DEVELOPMENT DETERMINATION PANEL MEETING

WEDNESDAY 4 DECEMBER 2024

ITEM 3.1	DA2024/0151 - 22 CUTLER ROAD CLONTARF - ALTERATIONS AND ADDITIONS TO A DWELLING HOUSE INCLUDING A SWIMMING POOL, PERGOLA AND LANDSCAPING
-----------------	---

Application Number:	DA2024/0151
---------------------	-------------

Figure 1 - Amended Roof Plan

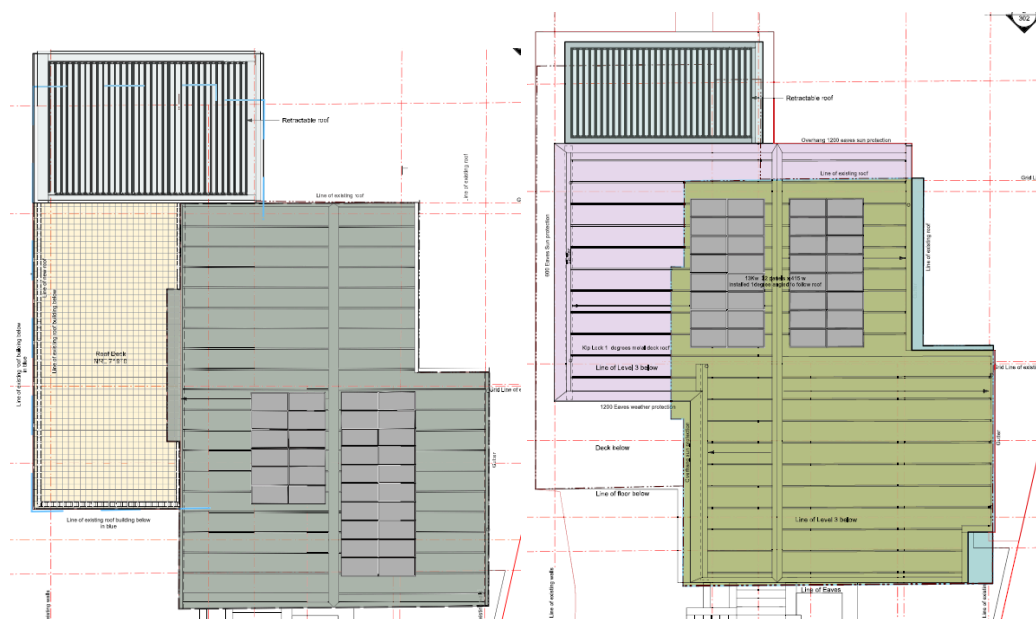
The proposed amendments can be summarised as follows:

- Level 3 western extension deleted and replaced with deck and pergola
- Minor extension to the level footprint.

The proposed amendments will have a reduced environmental impact on the adjoining properties and public open space than the original proposal. The amended plans result in a reduced development. Therefore, re-notification was not required in accordance with Northern Beaches Community Participation Plan. Notwithstanding this the amended plans were sent to the neighbouring properties to review.

Figure 1: Section plan - Height of building variation in pink.

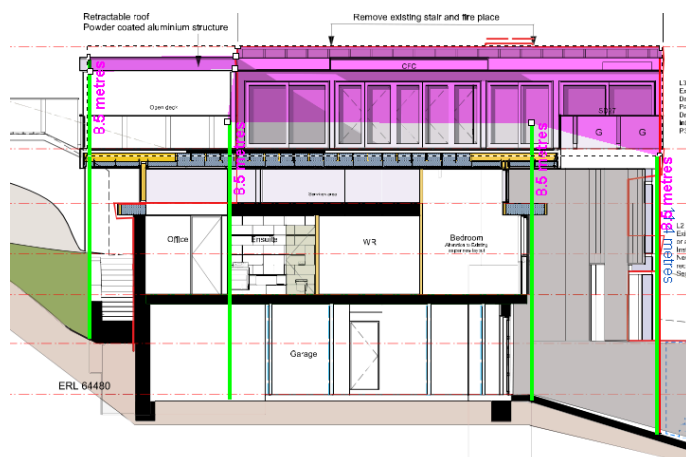
The 4.6 request for the non-compliance with the height of buildings development standard (8.5m) arises from the site being previously excavated to allow for the existing ground floor (labelled as L1 on the plans) and from the sloping topography of the site. The application proposes a maximum building of 11.4m.

Proposed: 11.4m

Percentage of variation: 34.1%

Figure 1: Proposed and existing shadow diagram and elevational shadow diagram for 9am.

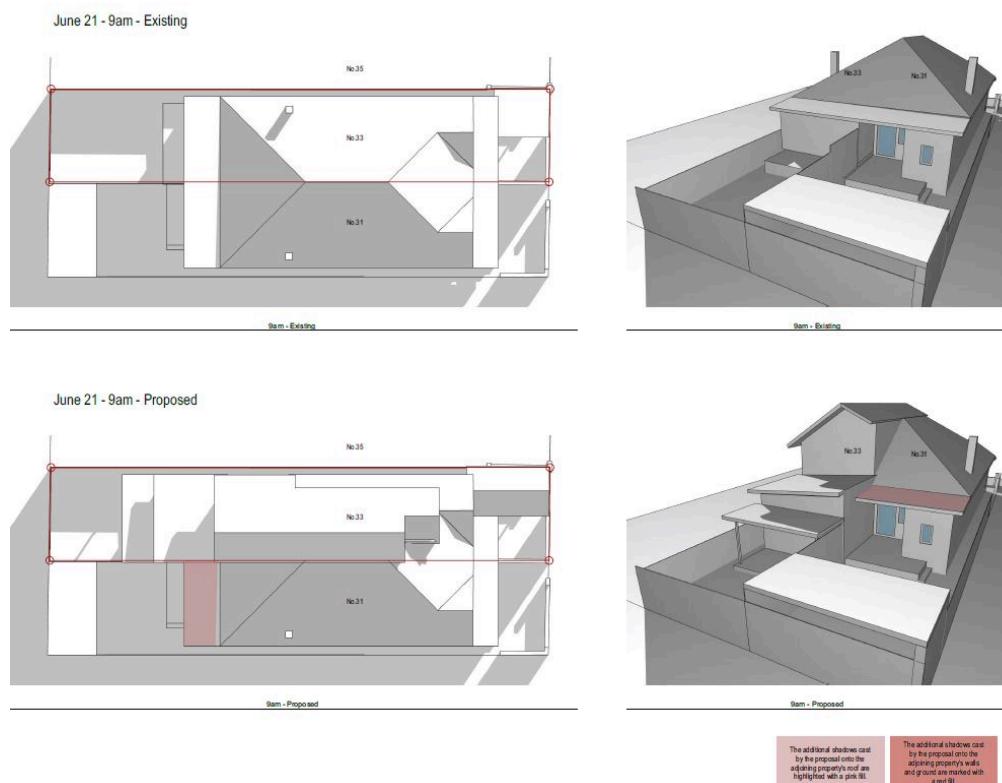
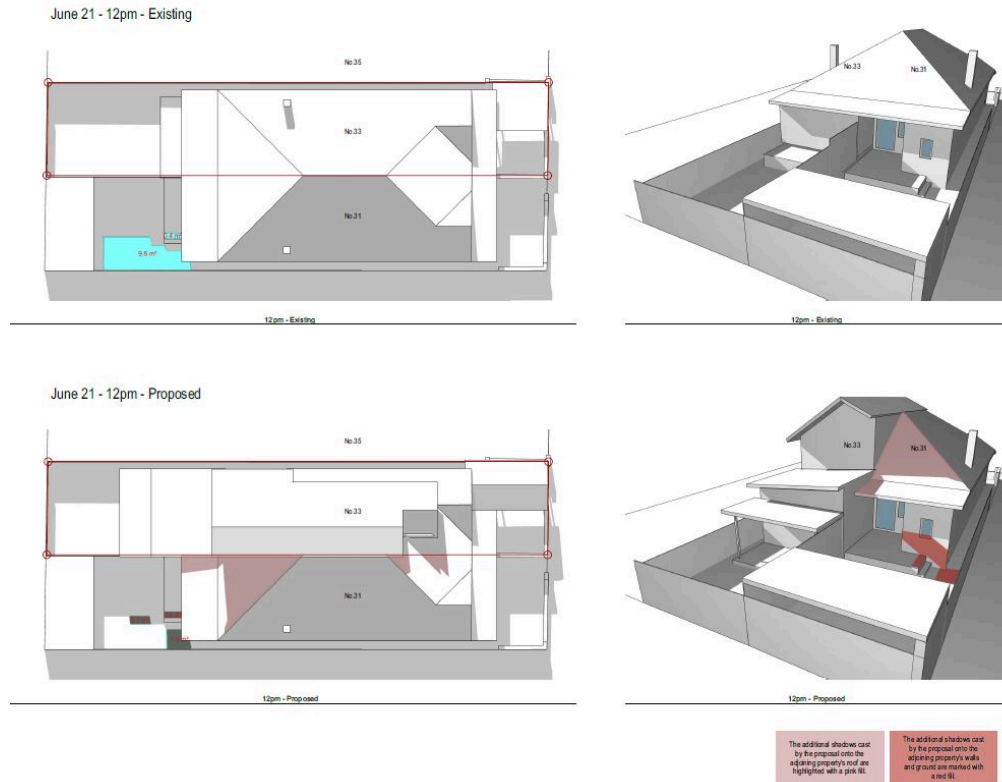
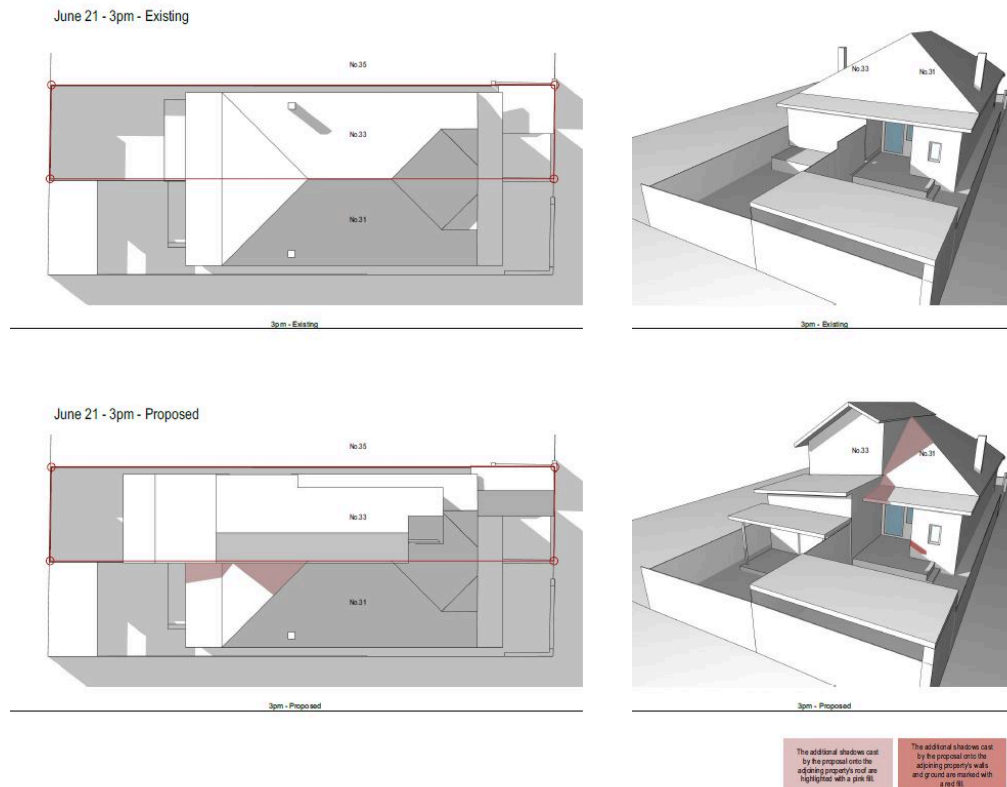
A minimum of 6 hours solar access be retained to a suitable clothes drying area.

The existing clothes drying area at no. 31 Quinton Road currently does not receive 6 hours of solar access. The proposed development will result in a minor loss of sunlight to this area between 9am to 3pm on the winter solstice (21 June).

Figure 4: North elevation showing locations on windows W13 and W15.

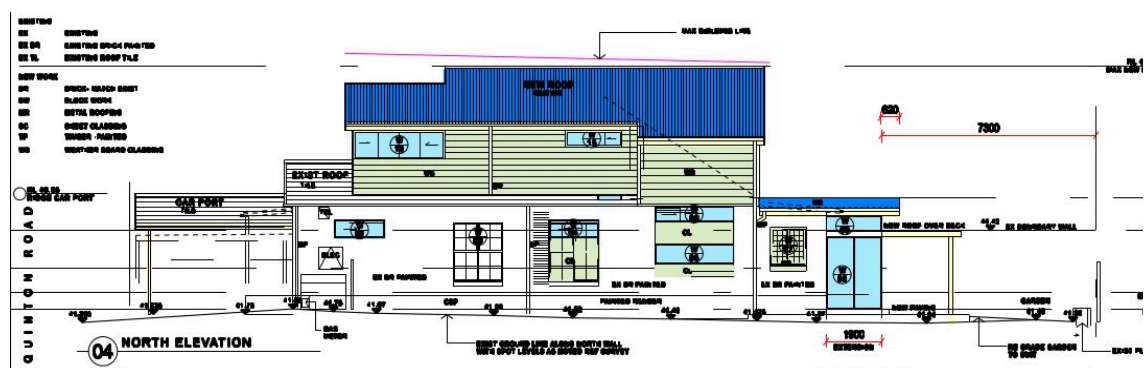
Window W15 is located off a bathroom, with a highlight window. A condition is recommended that it have opaque/translucent glass.

Window W16 is a east facing window located off a study/bedroom. The window will have fixed louvers to comply with BASIX requirements. This is considered sufficient to mitigate any privacy concerns from this window.

- Translucent glazing for Window W15 of western elevation first floor Ensuite Window,
- The Balustrade located off the first floor western elevation Study is to have a minimum height of 1.2m.
- The 'New Roof' as shown on plan DA 06 - Roof Plan is to be composed of tile which match colour and style of the existing Tiles on the roof and of the adjoining roof at no. 31 Quinton Road.
- Correct the Carport Ridge height on the plans DA 02 and DA 06 with RL45.65.

Figure 6: First floor plan showing front, side and rear boundary setbacks.

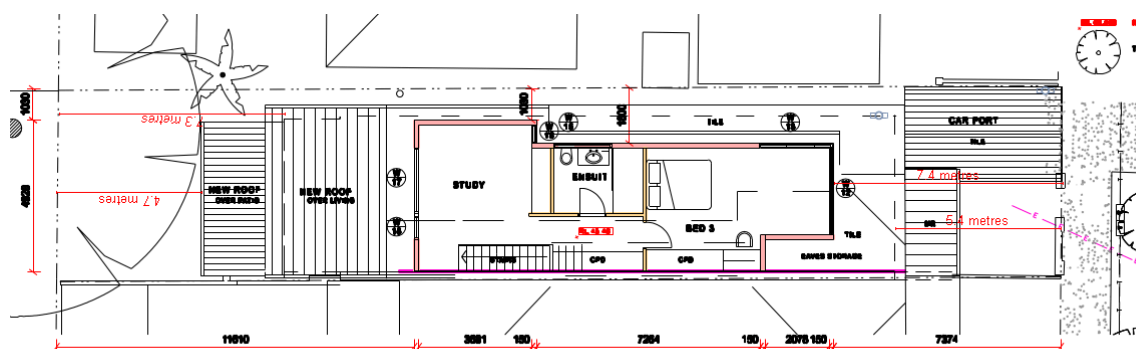
The proposed development provides for the following rear setback distances:

- Patio: 4.4m (presenting a variation of 45%)
- Ground floor: 7.3m (presenting a variation of 8.75%)
- First floor: 11.6m - complies

Figure 1. Proposed maximum building height (extent of breach indicated by yellow shading). Existing building height non-compliance indicated by blue shading.

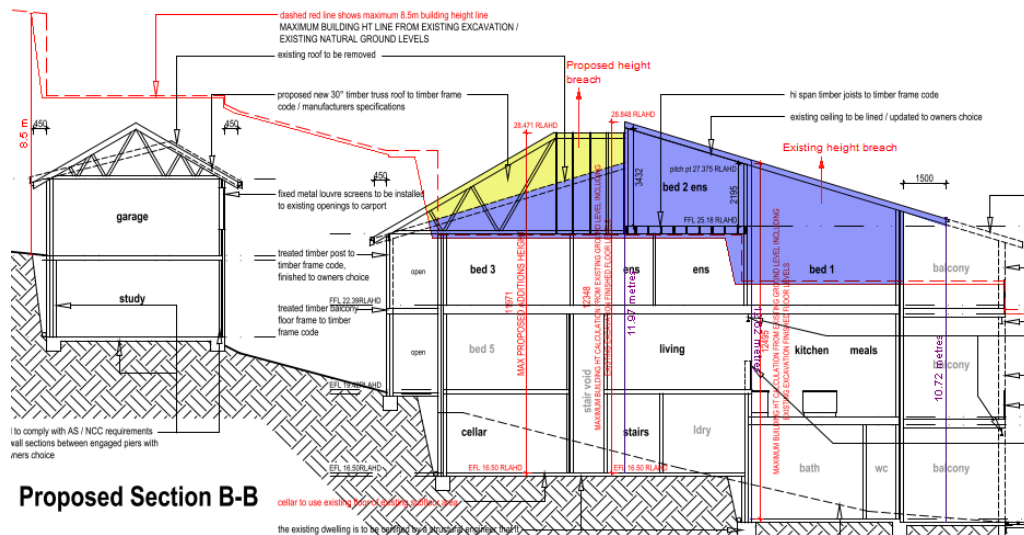
Proposed: 11.971 metres

Percentage of variation: 40.8%

Figure 3. North-eastern elevation envelope breach. Extent of proposed breach indicated by yellow shading. The green shading indicates the existing breach.

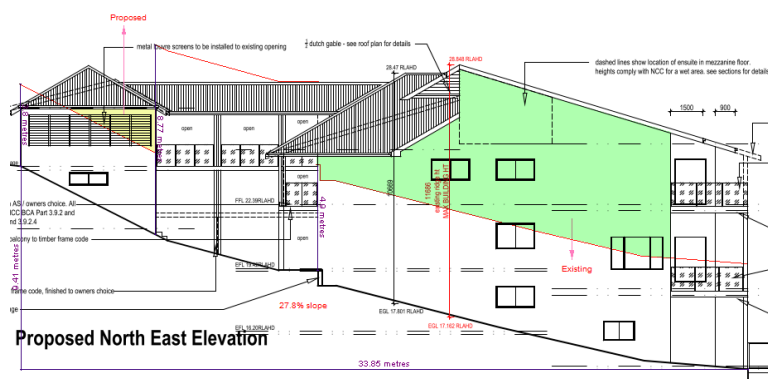
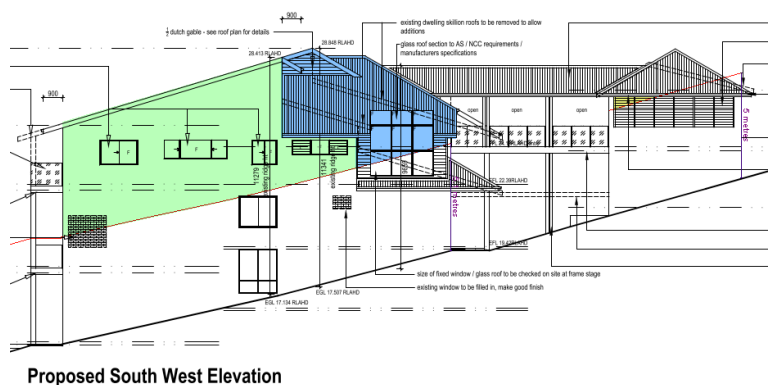
The proposed development results in a breach to the side boundary envelope along the north-eastern and south-western elevations, as shown in the figures below.
